ADDENDUM NO. 4

RED CLAY CONSOLIDATED SCHOOL DISTRICT
WILMINGTON CAMPUS RENOVATIONS
BID PACKAGE 'B'

This addendum is hereby made part of the Project Manual and Drawings dated 28 May 2013.

Sketch # EDIS-20130627-01
 Bid Pac B
 Construction Barrier Delineation

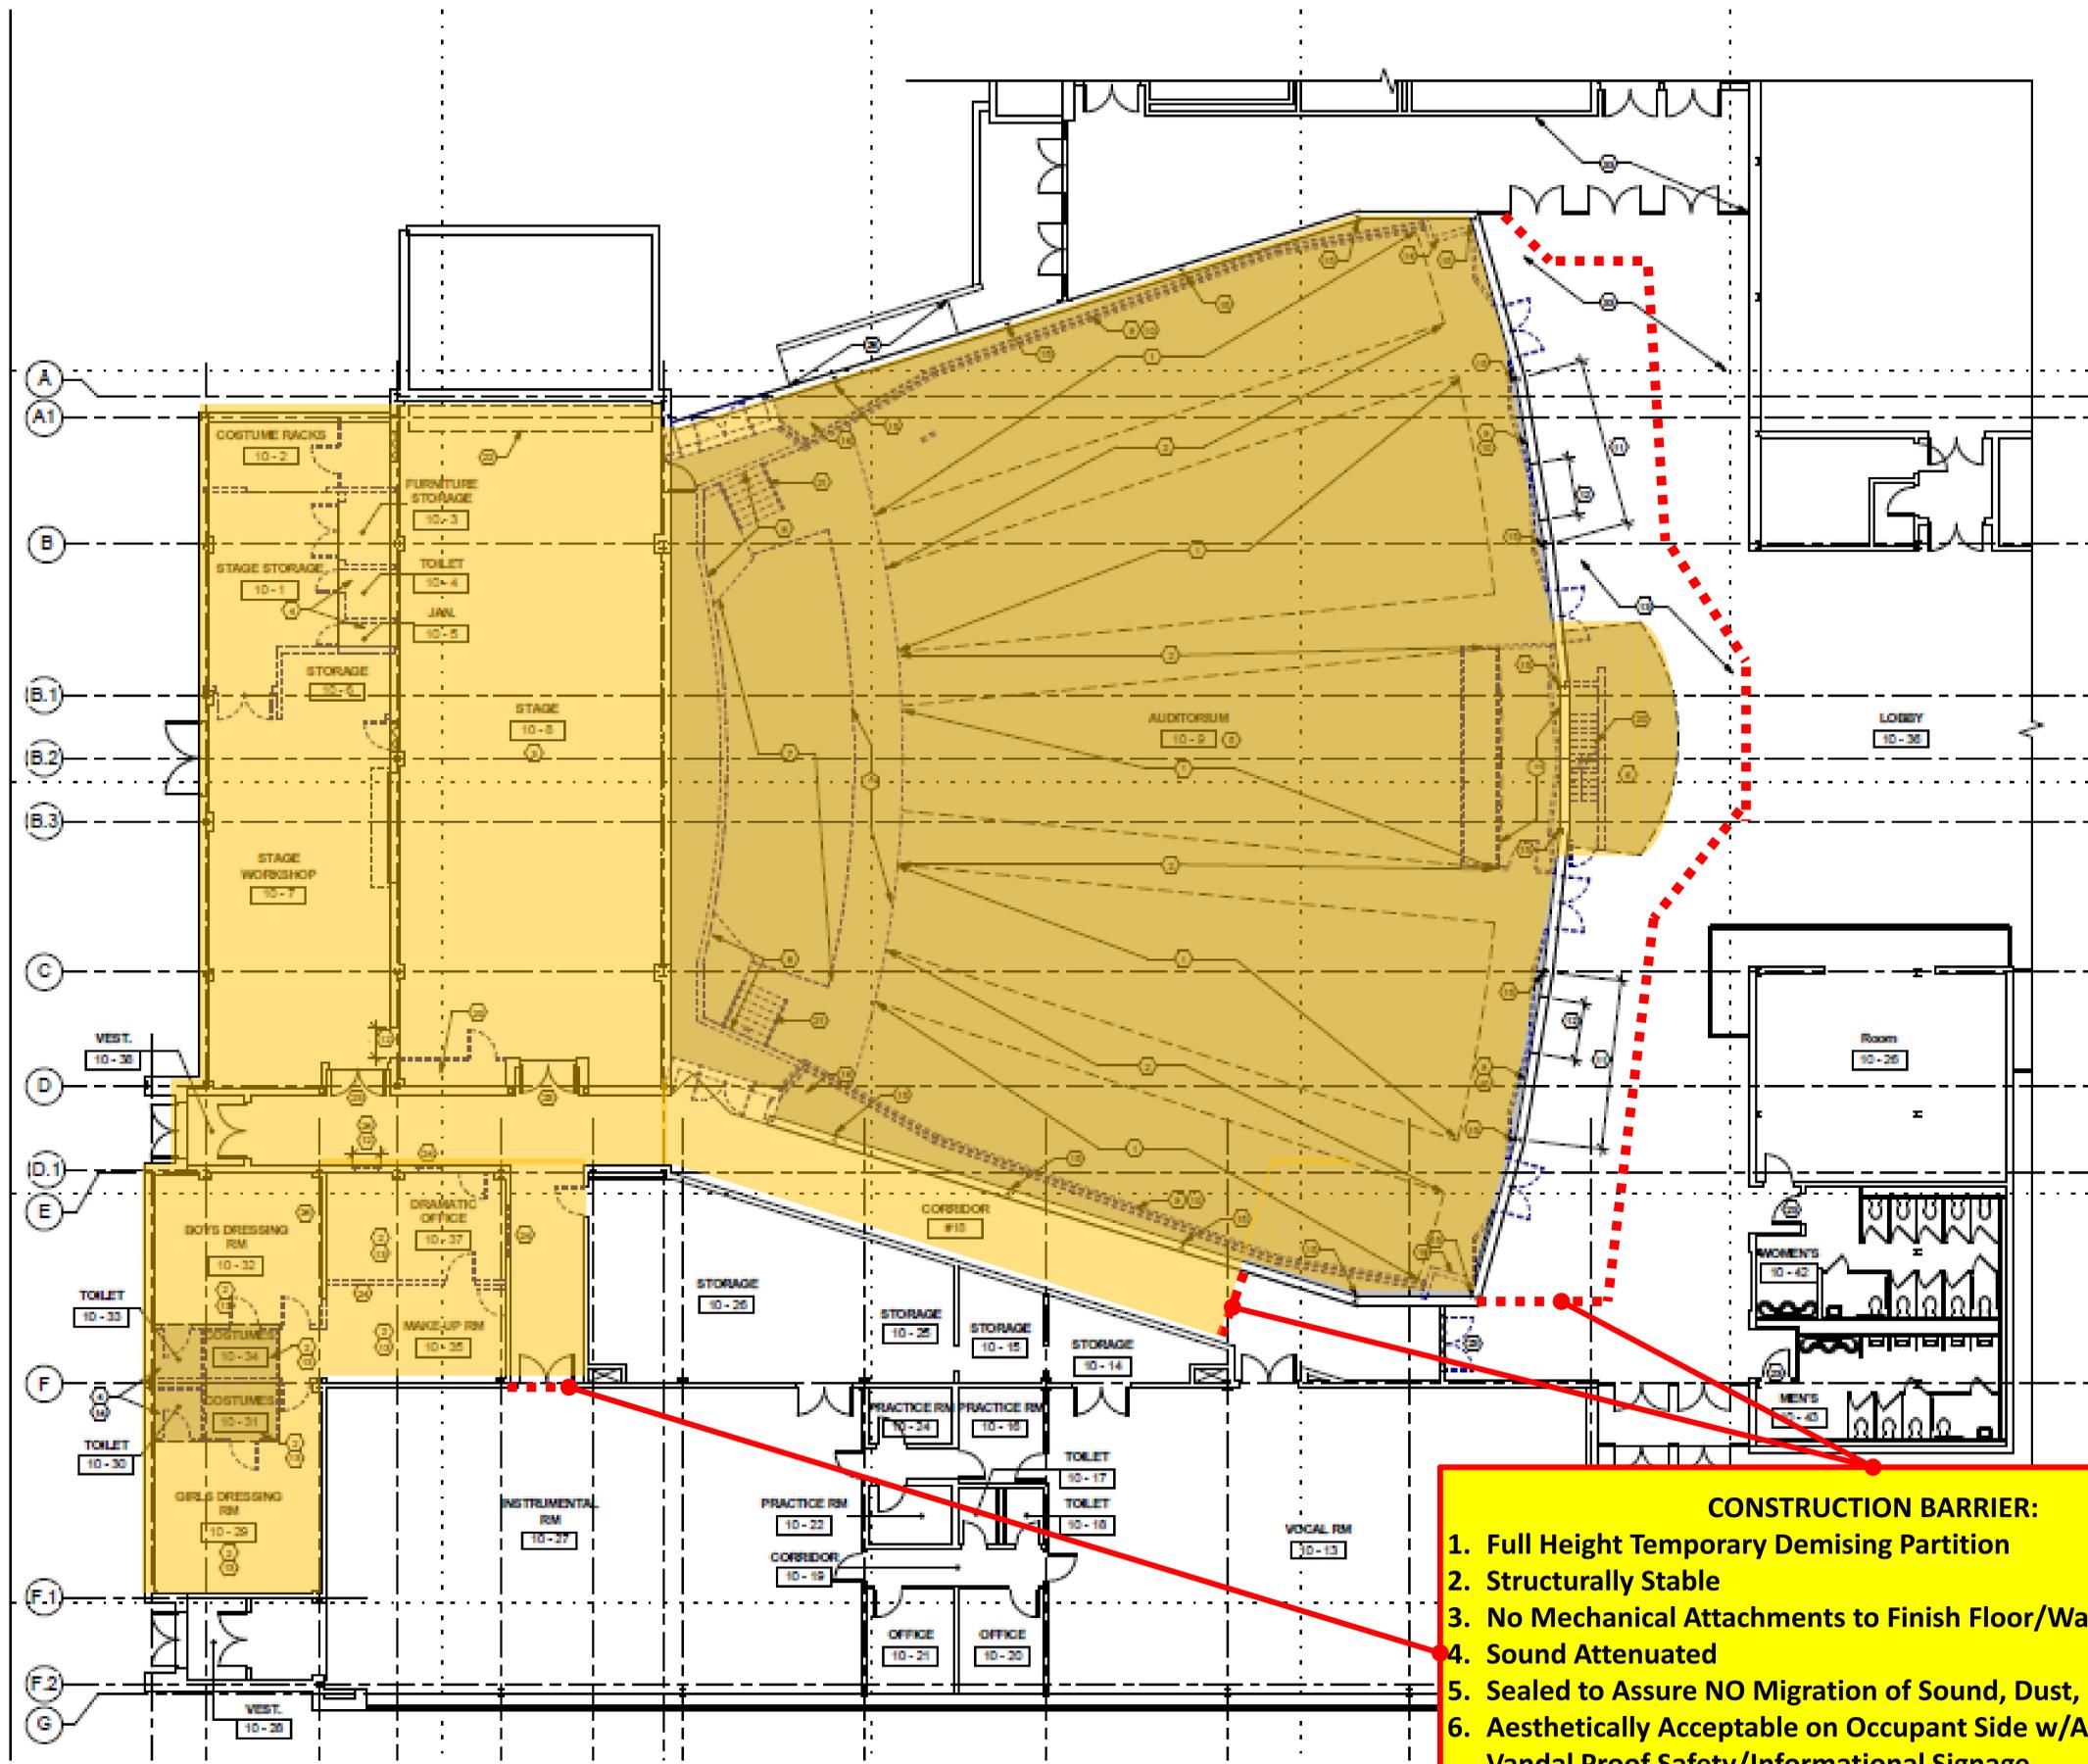
- CONSTRUCTION BARRIER:**
1. Full Height Temporary Demising Partition
 2. Structurally Stable
 3. No Mechanical Attachments to Finish Floor/Wall Systems
 4. Sound Attenuated
 5. Sealed to Assure NO Migration of Sound, Dust, or Odors
 6. Aesthetically Acceptable on Occupant Side w/Appropriate Vandal Proof Safety/Informational Signage
 7. Consider (3) Three Double Door Openings w/Locking Hardware
